**COMMANDER 114 SERIES
SERVICE PUBLICATIONS**

The following is a numerical list of all active Service Bulletins.

SERVICE BULLETIN NO. SB-114-1

AILERON CONTROL CHAIN REROUTING

Figure 1.

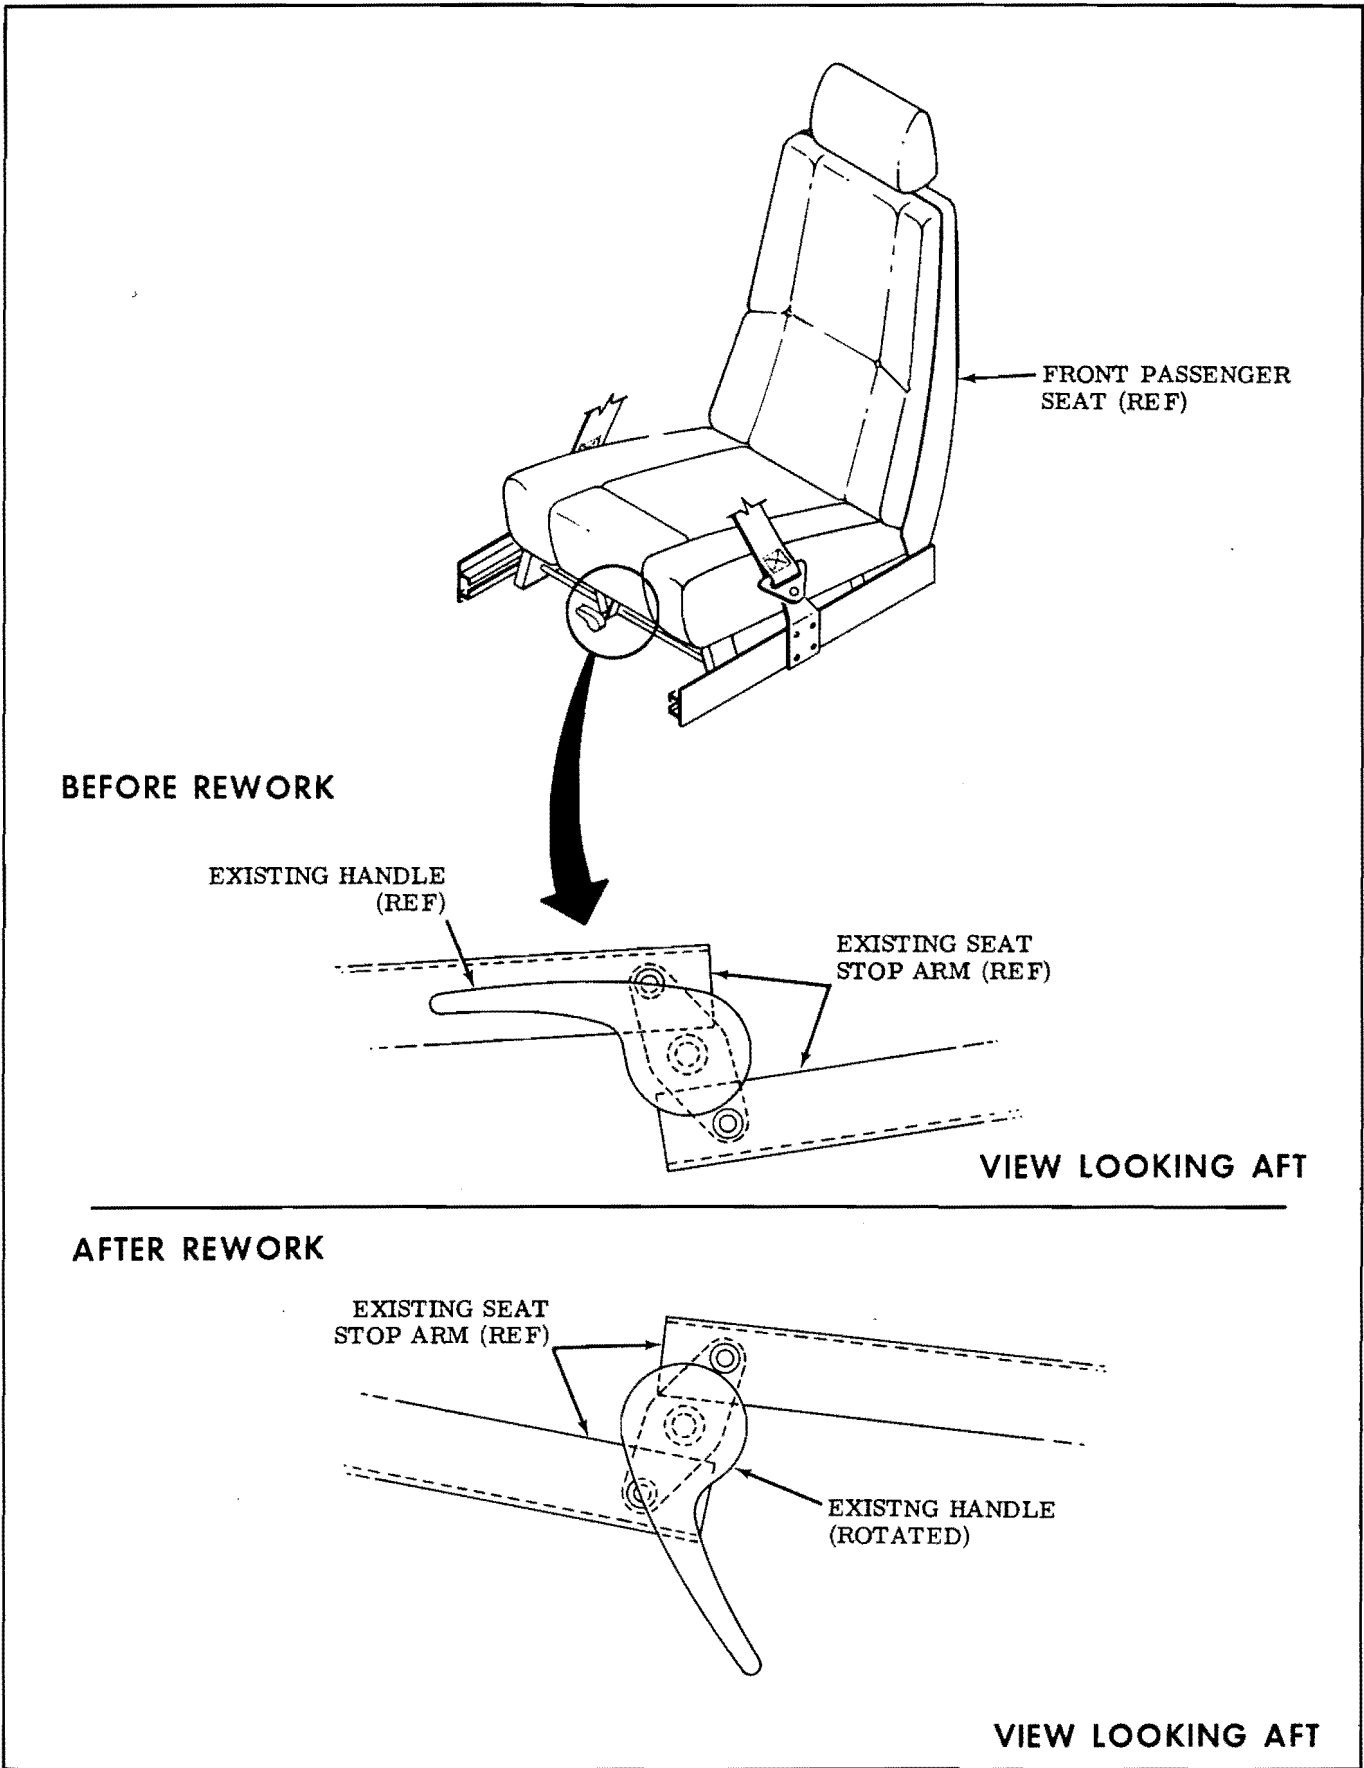
1. Remove existing seat stop arms from front passenger seat (see Figure 1.).
2. Rotate existing seat stop arms and reinstall on front passenger seat using existing hardware (see Figure 1.
3. Remove existing roll pin from seat locking mechanism handle, rotate handle and reinstall existing roll pin (see Figure 1.).
4. Pull up on seat locking mechanism handle to disengage locking pins and release handle to assure that locking pins are locked into seat tracks.
5. Fill out and mail Compliance Card.

Figure 1.

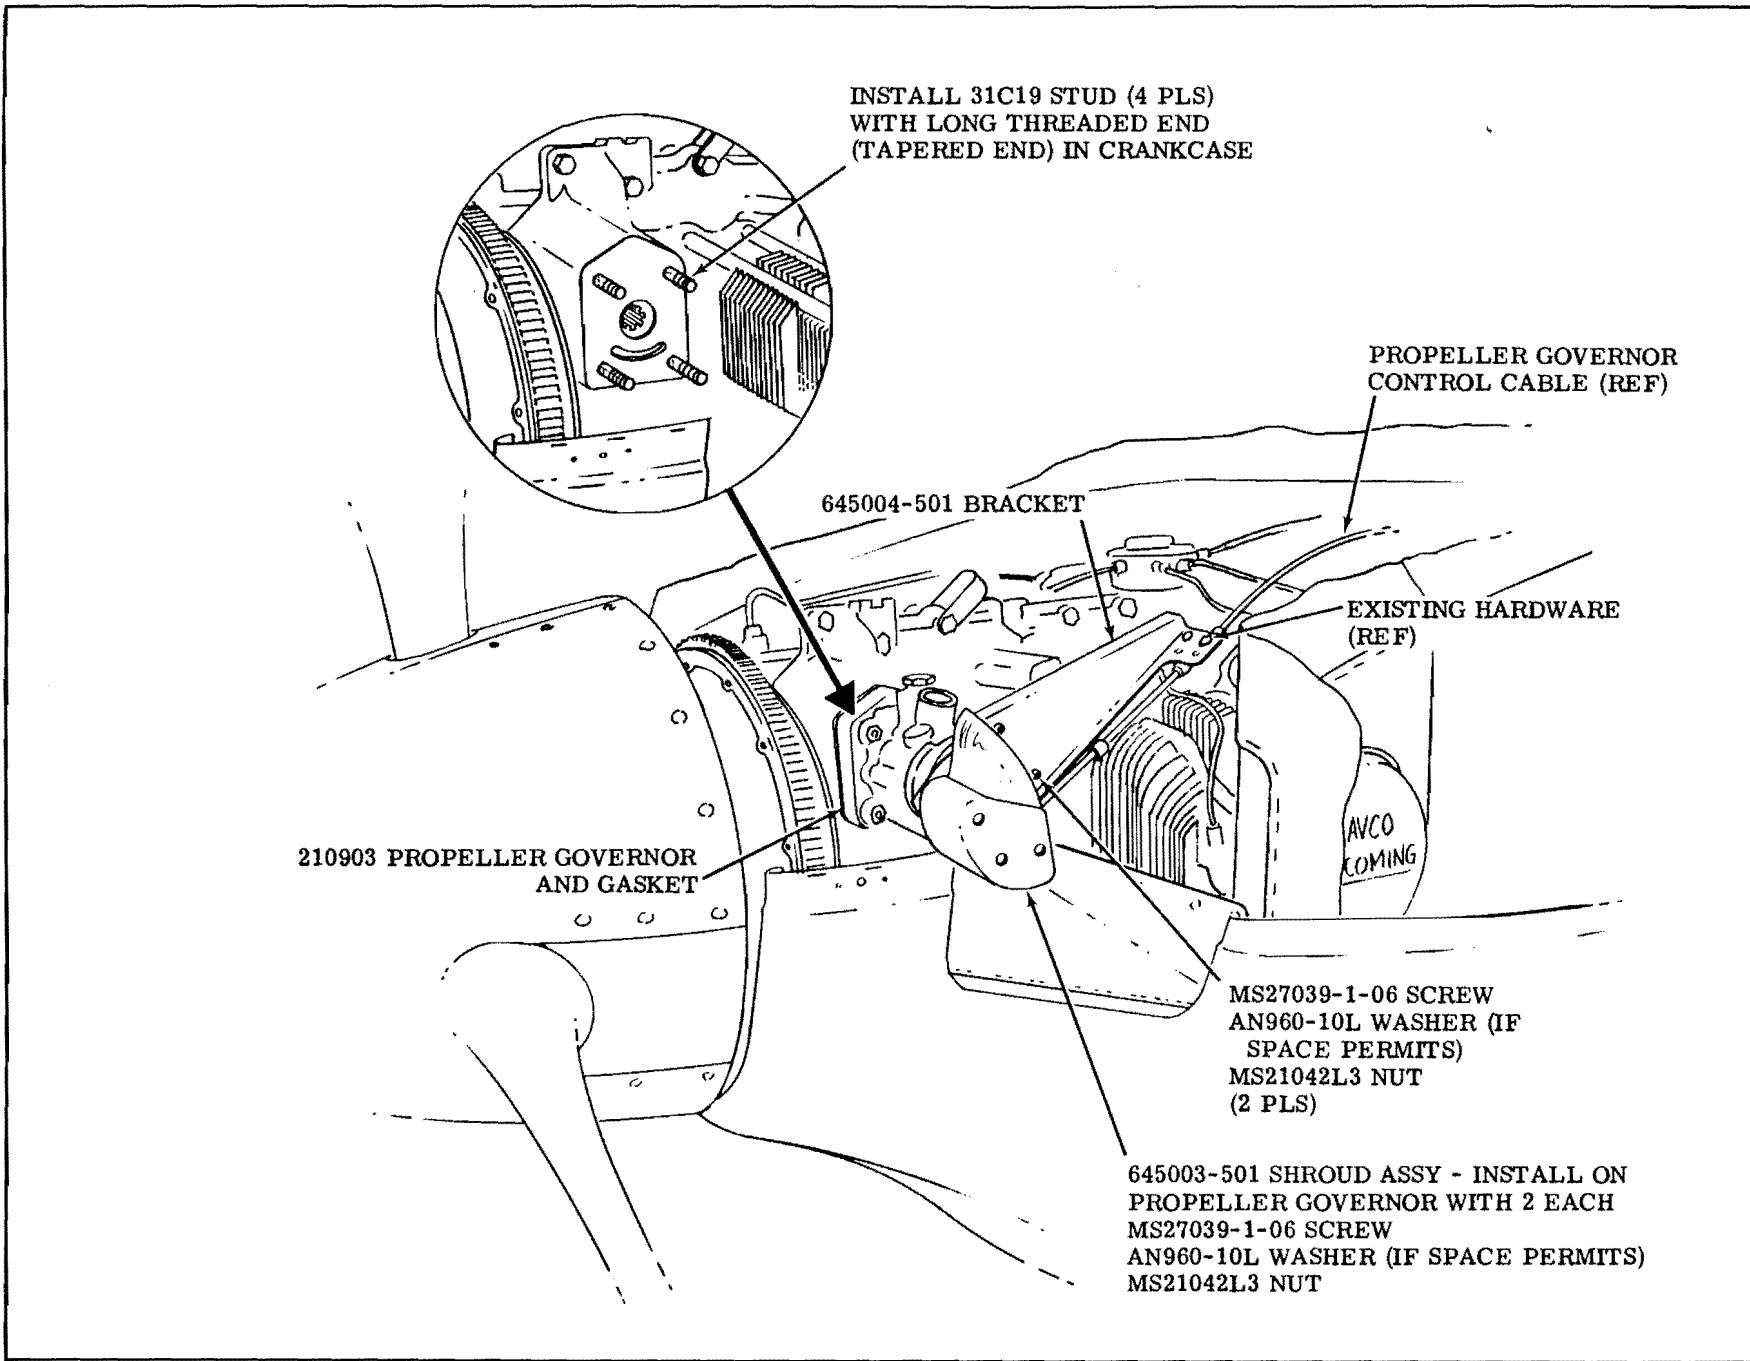
5. Remove existing propeller governor from engine.
6. Remove existing propeller governor mounting studs from engine crankcase.
7. Install 31C19 stud (4 places) on engine crankcase. Studs should be threaded 0.70-inch into crankcase with approximately 1.68-inches of stud exposed. Install end with most threads (tapered end) into crankcase (see Figure 1.).

9. Install 645004-501 bracket on propeller governor with MS27039-1-06 screw (2 places) and MS21042L3 nut (2 places) (see Figure 1.).

10. Connect propeller governor control cable to propeller governor and install cable on bracket using existing hardware (see Figure 1.).
11. Install 645003-501 shroud assembly on propeller governor with MS27039-1-06 screw (2 places) and MS21042L3 nut (2 places) (see Figure 1.).

Figure 2.

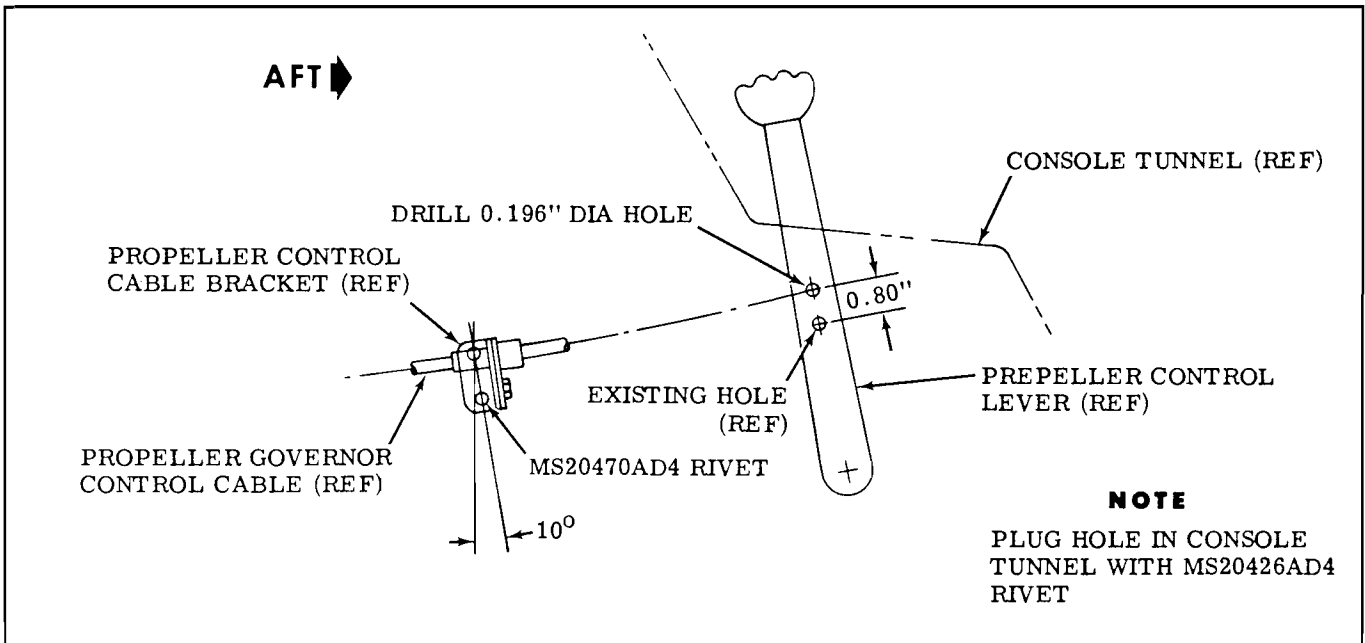
12. Remove knobs from engine control levers.
13. Remove fuel selector knob assembly.
14. Remove quadrant friction control knobs.
15. Remove quadrant plate and console cover.
16. Remove metal console covers to gain access to Propeller Control cable.
17. Disconnect propeller governor control cable from control lever.
18. Pull carpet away from right side of console tunnel to expose rivets that attach propeller governor control cable bracket to console tunnel.
19. Drill out lower rivet that attaches propeller governor control cable bracket to console tunnel, rotate bracket and plug hole in console tunnel with MS20426AD4 rivet (see Figure 2.).

Figure 1.

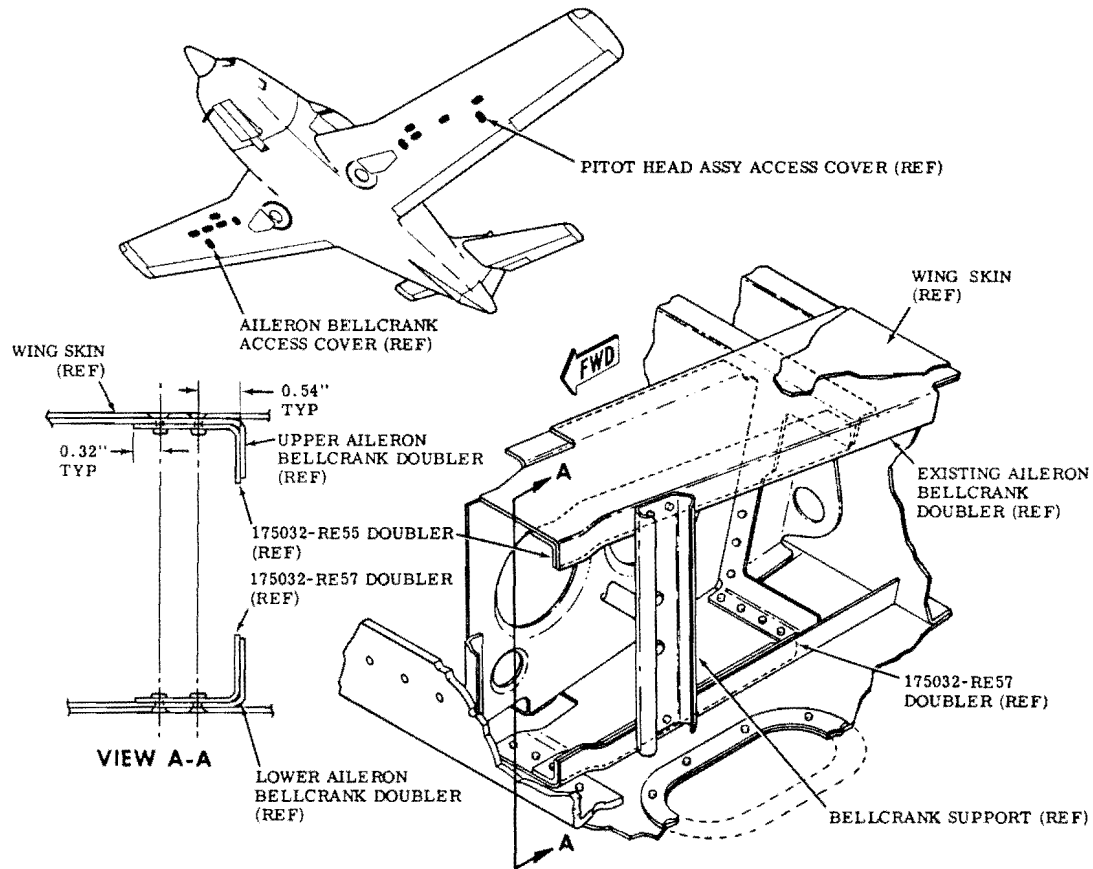
3. Locate, drill and install 175032-RE55 doubler (left wing) and 175032-RE56 doubler (right wing) on upper aileron bellcrank doubler (see Figure 1.).
4. Locate, drill and install 175032-RE57 doubler (left wing) and 175032-RE58 doubler (right wing) on lower aileron bellcrank doubler (see Figure 1.).
5. Reinstall pitot head assembly access cover on lower left wing skin.
6. Reinstall access cover on lower right wing skin.
7. Repaint wing surfaces as necessary.
8. Fill out and mail Compliance Card.

Figure 1.

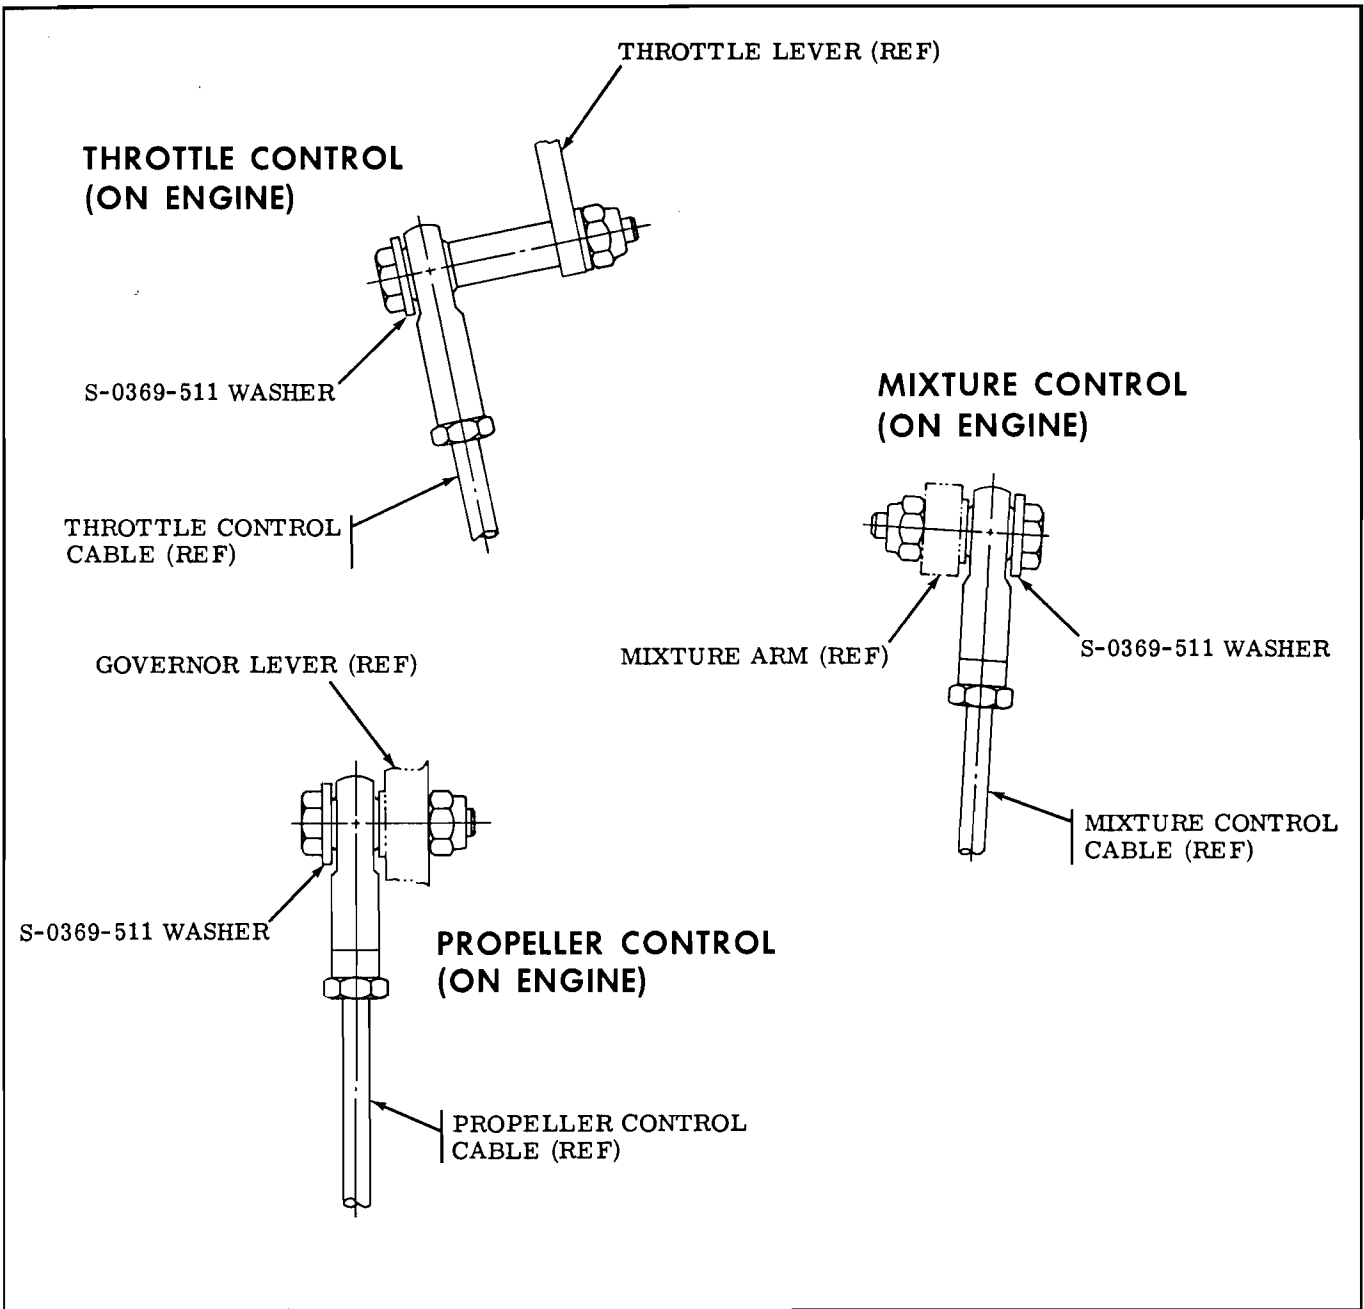
1. Remove upper cowling from engine.
2. Remove and discard existing large aluminum washer from throttle control lever, mixture control arm and prop governor lever and install S-0369-511 steel washers (see Figure 1.).

Figure 1.

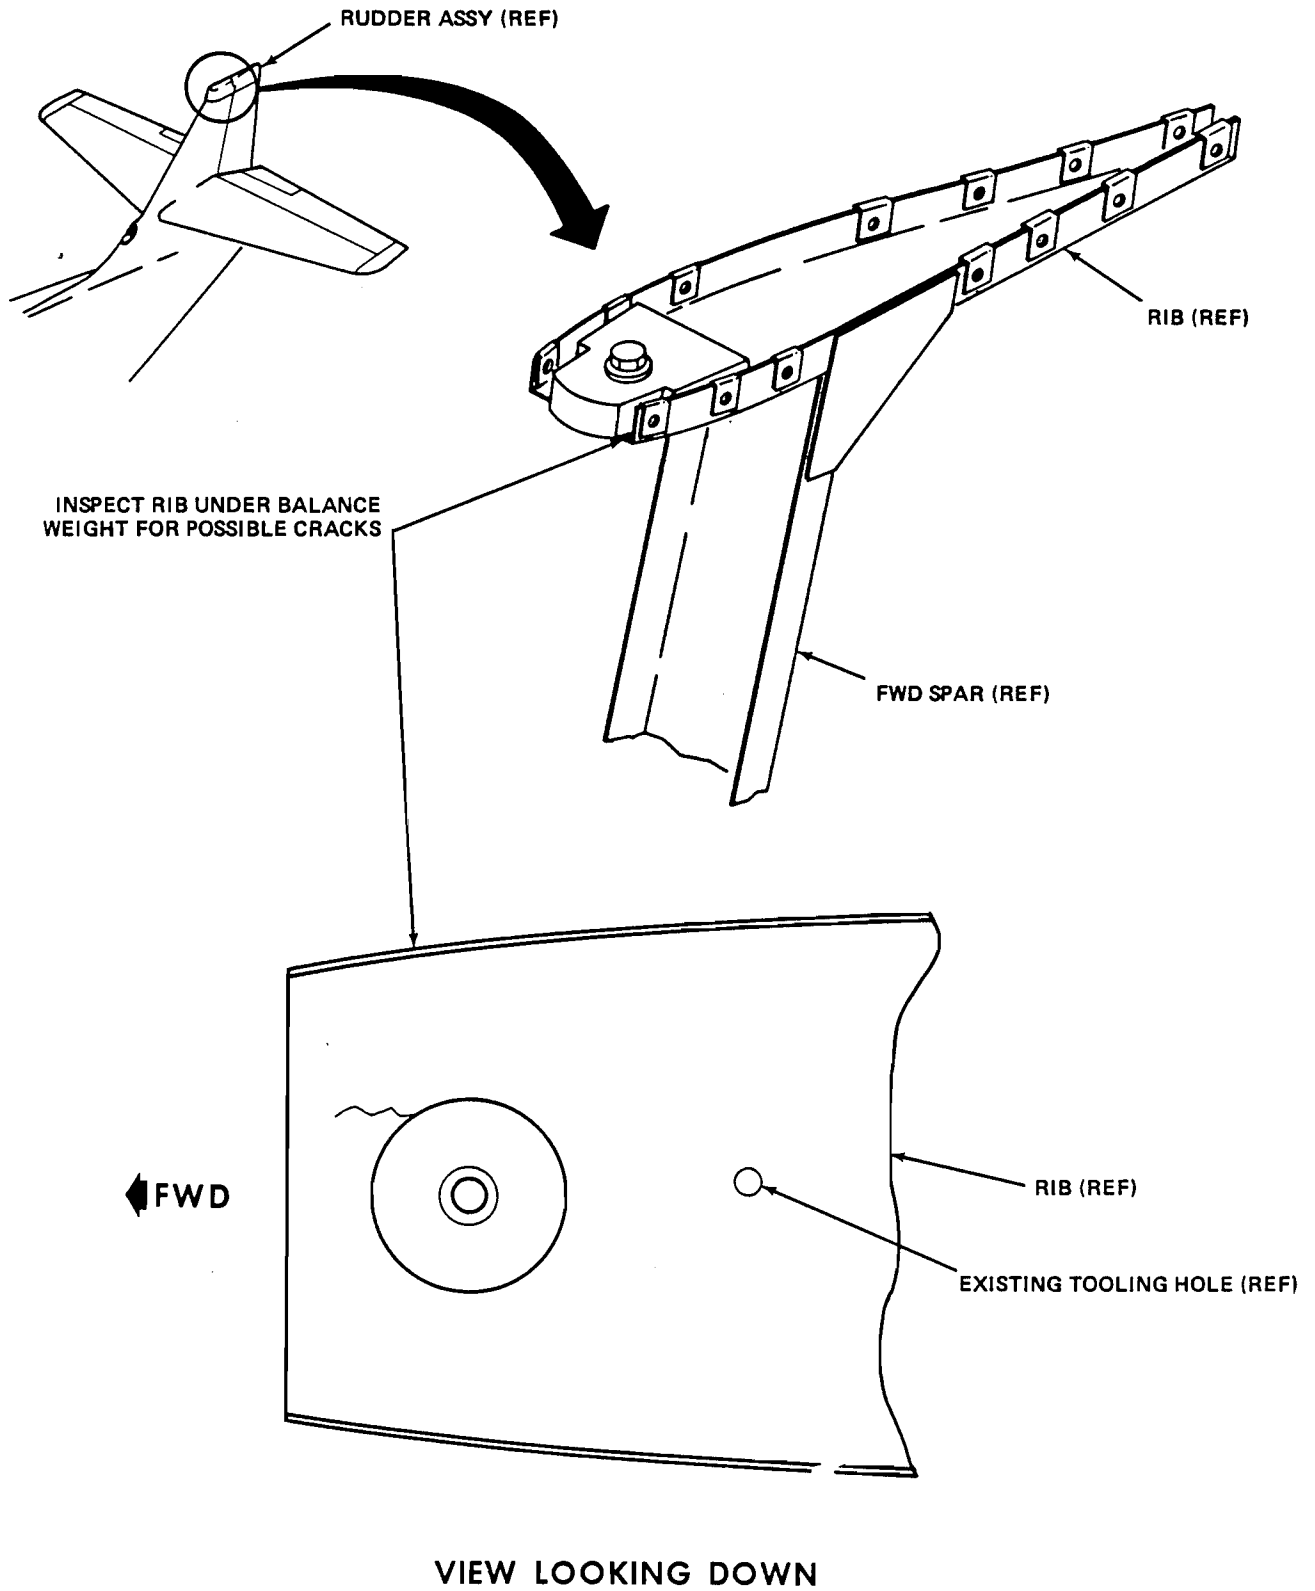
1. Inspect rudder tip rib in area around balance weight attaching hole to check for cracks (refer to Figure 1).

2. If no cracks are found, proceed to step 4.
3. If cracks are found in area of balance weight attaching hole, proceed to Part II of this Service Bulletin.
4. Fill out and mail Compliance Card specifying that Part I of this Service Bulletin has been accomplished. Note if any cracks were found.
5. Proceed to RECORD COMPLIANCE.
